**Identification cards — Contactless
integrated circuit cards — Proximity
cards —**

**Part 3:
Initialization and anticollision**

**AMENDMENT 1: Electromagnetic
disturbance handling and single-size unique
identifier**

Amendment 1 to ISO/IEC 14443-3:2011 was prepared by Joint Technical Committee ISO/IEC JTC 1, *Information technology*, Subcommittee SC 17, *Cards and personal identification*.

Figure 17 — Timing before the PICC SOF

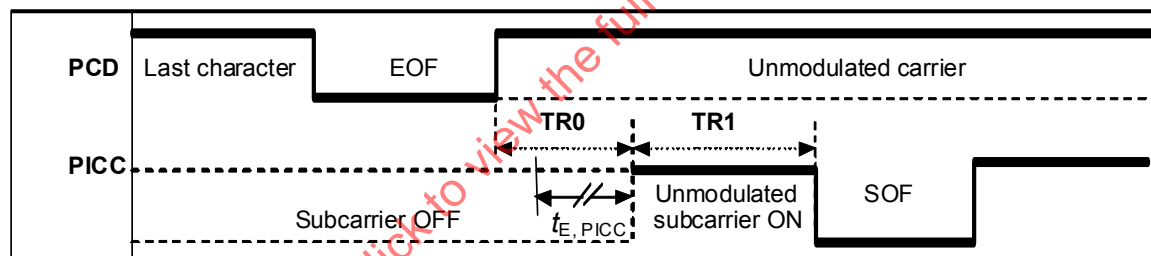
Page 27, 7.1.6

Replace Figure 17 with the following:

NOTE $t_{E,PICC}$ is specified in Clause 8.

Figure 33 — Low EMD time

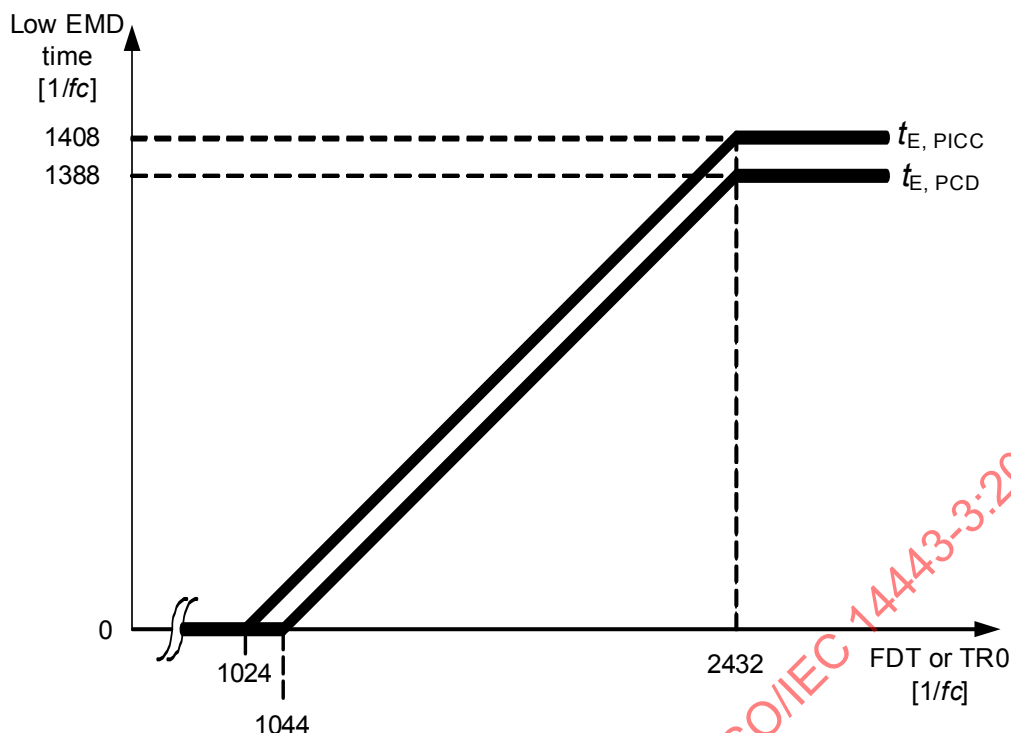
Insert the following new clause after Figure 32:

8 Electromagnetic disturbance handling

The low EMD time for PCD and PICC are illustrated in Figure 33.

The low EMD time $t_{E,PICC}$ is the time period before the start of PICC data transmission, when the PICC shall not produce an EMD level higher than the EMD limit as defined in ISO/IEC 14443-2/Amd.1.

This low EMD time $t_{E,PCD}$ has a value of $F - 1044/f_c$ with a maximum value of $1388/f_c$ where F equals FDT for Type A and TR0 for Type B. The value is $0/f_c$ for $TR0 \leq 1044/f_c$.
